# Namas Wind Farm, Northern Cape Province

Motivation for amendment of Environmental  
Authorisation

DEA Ref.: 14/12/16/3/3/1/1971

October 2019

**Figure 2.1:** Proposed amended Namas Wind Farm layout map (A3 Map included in **Appendix I**).

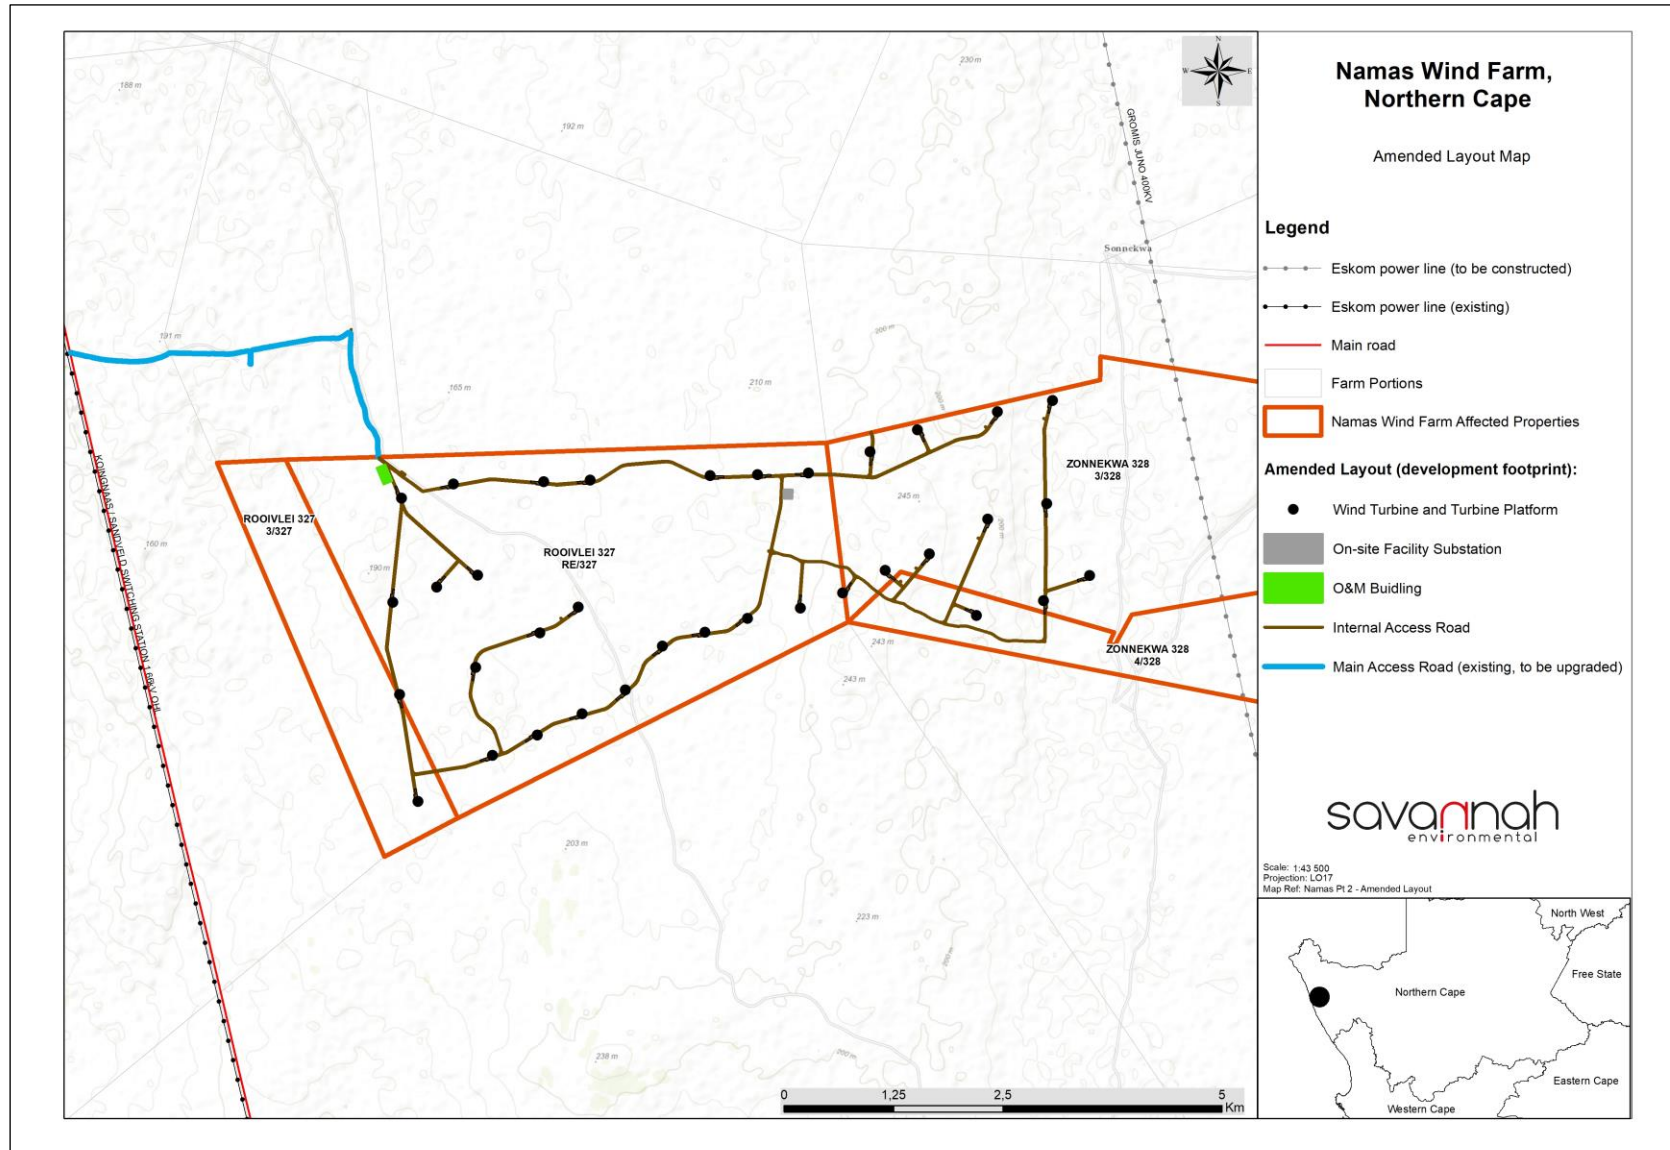
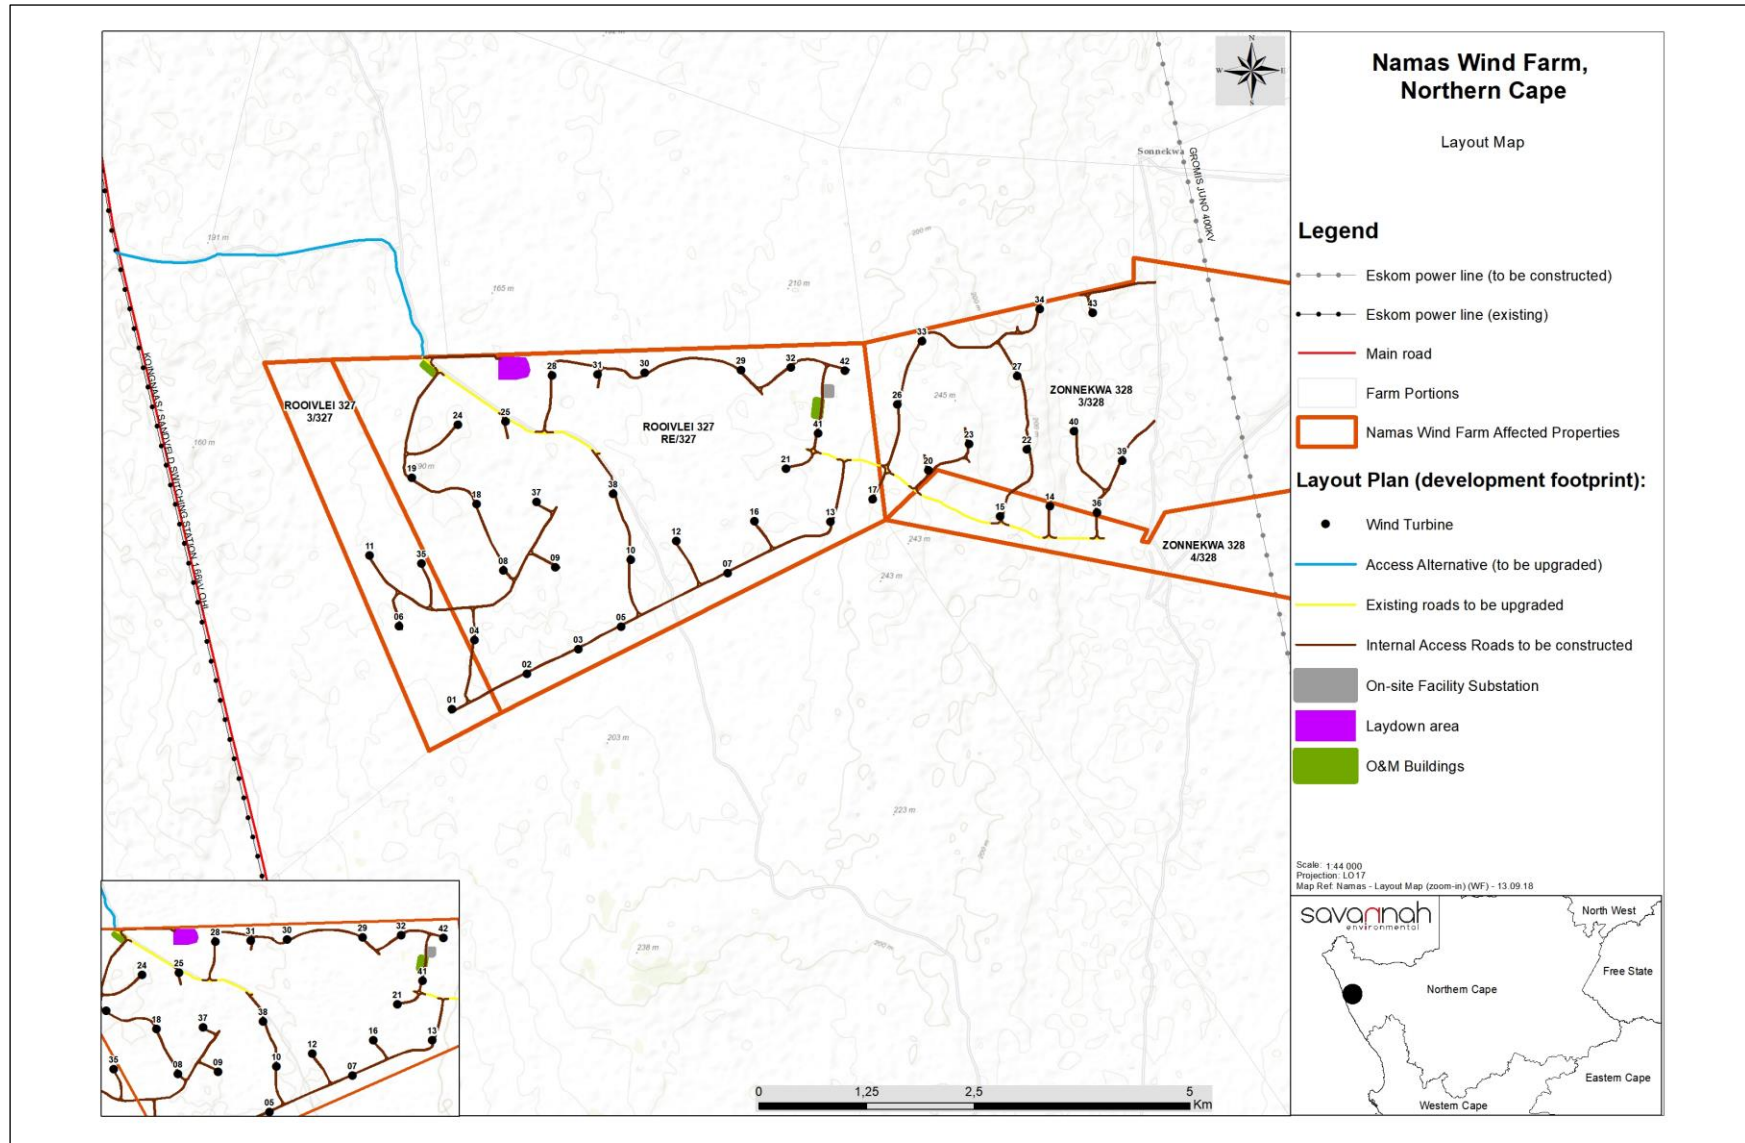
The proposed amended layout is presented in **Figure 2.1**. The layout was provided to the specialists for assessment and input in terms of the suitability of the layout for implementation and the identification of additional mitigation measures (if required). **Figure 2.2** includes the layout as was assessed during the BA process and included in the final BA Report submitted to DEFF for decision-making on the application for EA.

It must be noted that this amended layout is submitted to DEFF for review and approval in accordance with Condition 13 of the EA.

**Figure 5.1:** Updated bat sensitivity map that must be adhered to for the development of the Namas Wind Farm amended layout

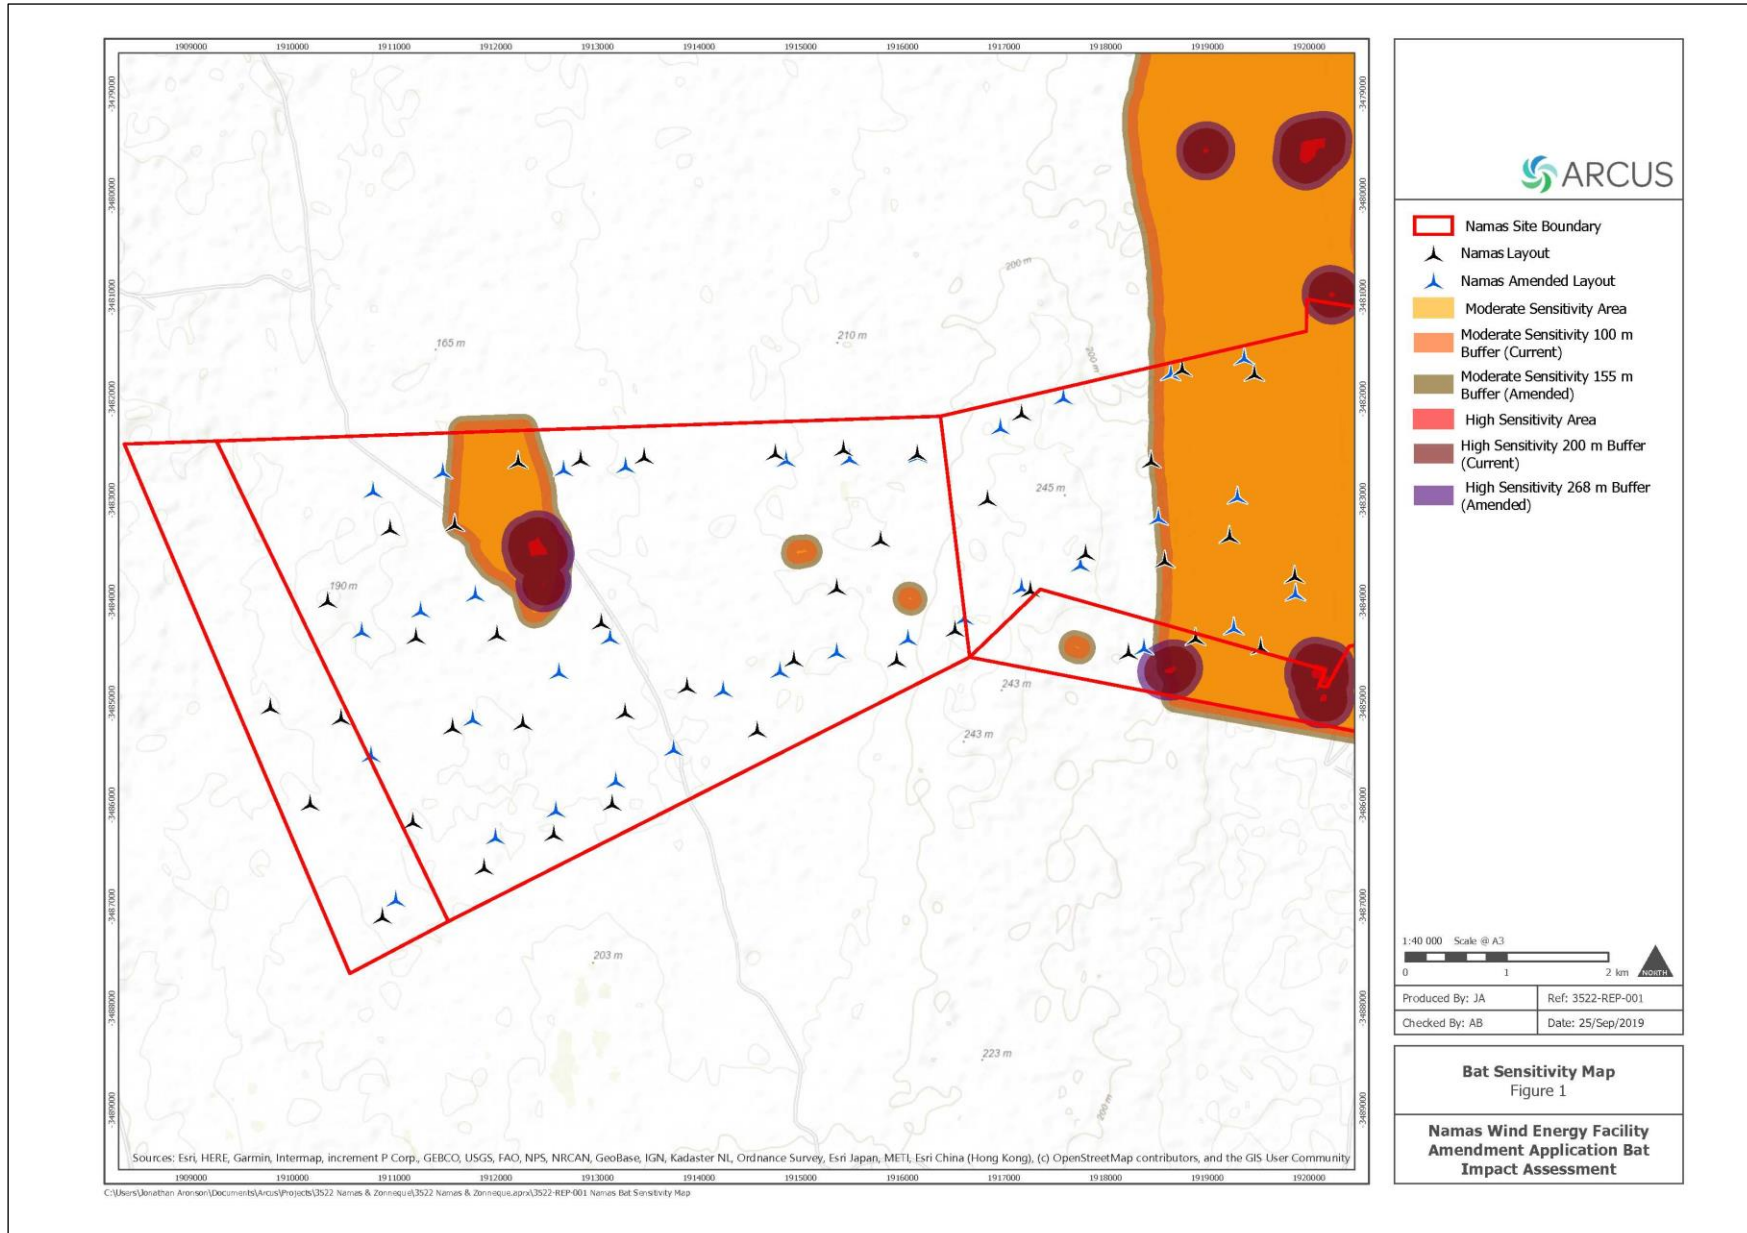
Considering the Bat Impact Assessment and the proposed amendments to the turbine dimensions, it is not expected that the amendments will result in an increase in the overall bat impacts. Cumulative mortality impacts would also not increase beyond what was previously identified, assessed and rated. However, there may be additional impacts to high flying species because the blade tips will extend higher into the air. Risks to lower flying species may be reduced as the blades will be higher above the ground.

The key mitigation measure that should be implemented at the Namas Wind Farm would be adherence to the updated sensitivity map (**Figure 5.1**). The sizes of the bat buffers have been increased to reflect the changes in the turbine size. An additional mitigation measure recommended by Animalia (2018) is that curtailment via blade feathering (90-degree feathering below the manufacturer's cut in speed) must be applied to all turbines from sunset until sunrise every night during March, April, May, August and September. The requirements of curtailment and blade feathering and the application thereof, as contained in the EMPr and contained in the Bat Impact Assessment by Animalia 2018, still apply and no changes to this have been made based on this assessment. Operational monitoring must also be carried out as per best practise (i.e. for a minimum of two years) and based on these results, adjustments to the curtailment may be needed or the use of acoustic deterrents investigated. If these mitigation measures are adhered to, the specialist accepts the proposed amendments.

- » The key mitigation measure that should be implemented at the Namas Wind Farm would be adherence to the updated sensitivity map (Figure 5.1 of section 5).<sup>7</sup>

**Figure 5.2:** Namas Wind Farm amended layout overlain with the ecological sensitivity of the project site

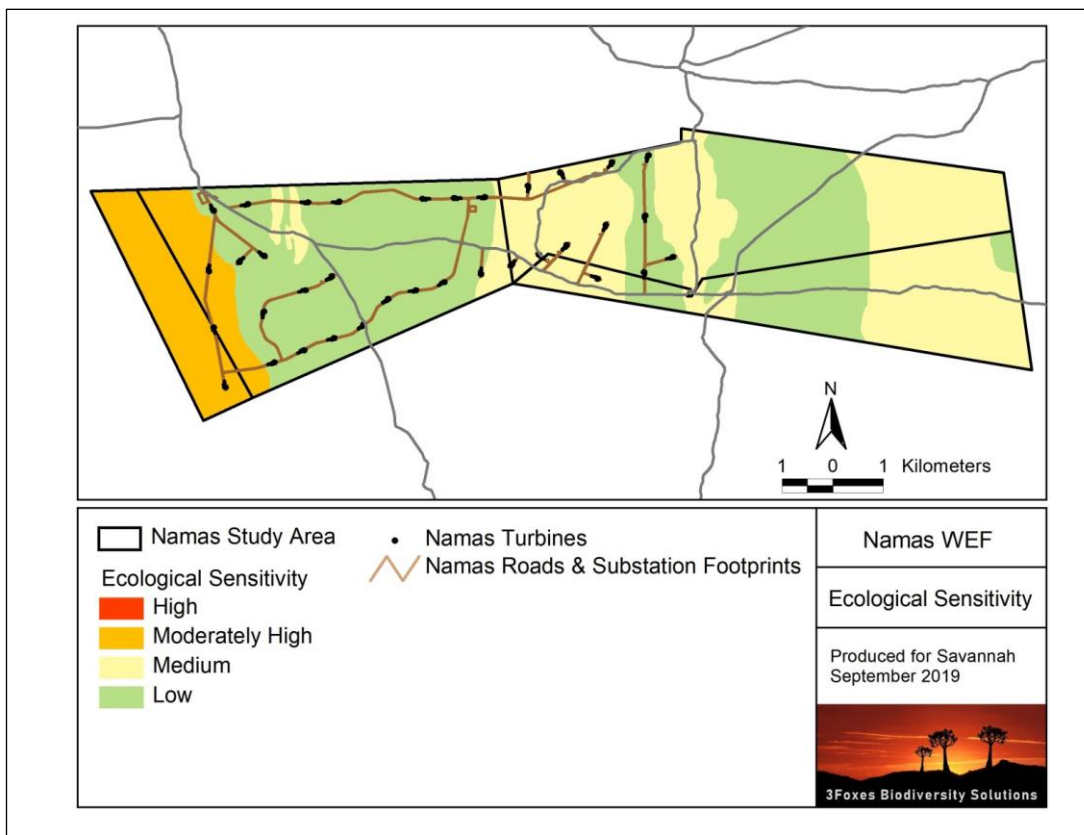
The specialist has considered the proposed amended layout and the ecological sensitivity of the project site. The ecological impact of the amended 35 turbine layout is likely to be similar (with a negligible reduction) to the original 43 turbine layout as a result of the reduced number of turbines within the higher sensitivity parts of the site, as well as the slightly reduced extent of access roads associated with the amended layout (**Figure 5.2**). No new impacts are expected to occur with the implementation of the amended layout.

The total footprint of the wind farm would be marginally reduced but this is not considered sufficient to change the overall ecological impact of the amended layout as compared to the original layout assessed in the BA process. The larger turbine size is not considered to be of consequence with regards to terrestrial impacts as, while the turbine hard stand may be larger for each turbine, the reduction in the number of turbines would compensate for any increase in footprint associated with each turbine.

**Figure 5.3:** Comparative viewshed analysis for the authorised layout and amended layout of the Namas Wind Farm

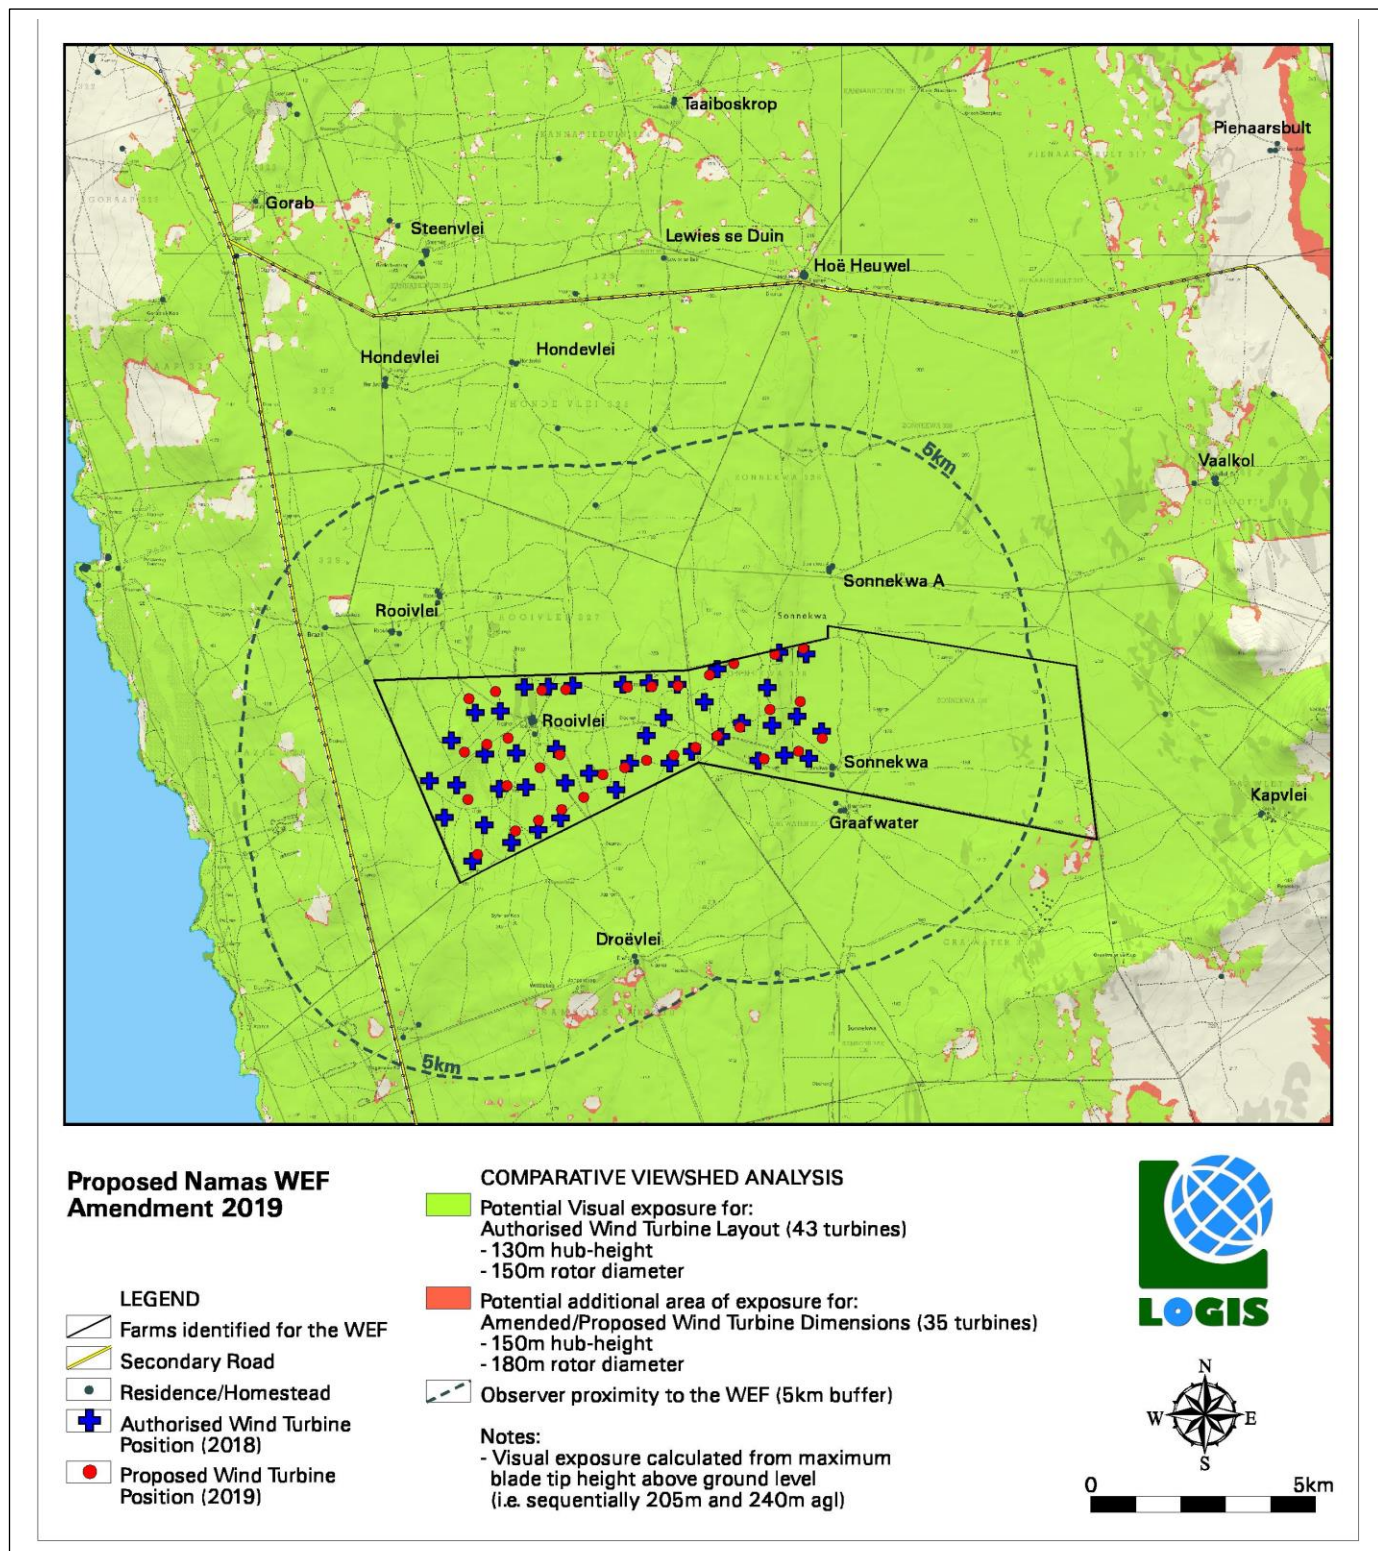
A viewshed analysis was undertaken from each of the authorised wind turbine positions (43 in total) at an offset of 205m (maximum tip height) above ground level. The result of this analysis represents the potential total visual exposure of the original and authorised turbine dimensions (indicated in green in **Figure 5.3**). The viewshed analysis was repeated at an offset of 240m to indicate the visual exposure (shown in orange in **Figure 5.3**) of the increased turbine dimensions and reduced number of turbines (35 in total) proposed as part of the amendment.

The increased area of visual exposure does not include a significant portion of additional exposure to the secondary roads within the area.

In spite of the reduction in the number of turbines it is expected that the wind turbine structures, both the original dimensions and the proposed increased dimensions would be equally visible and noticeable from both the roads and homesteads identified above. This signifies a negligible change to the potential visual impact with the implementation of the increased turbine dimensions and amended layout.
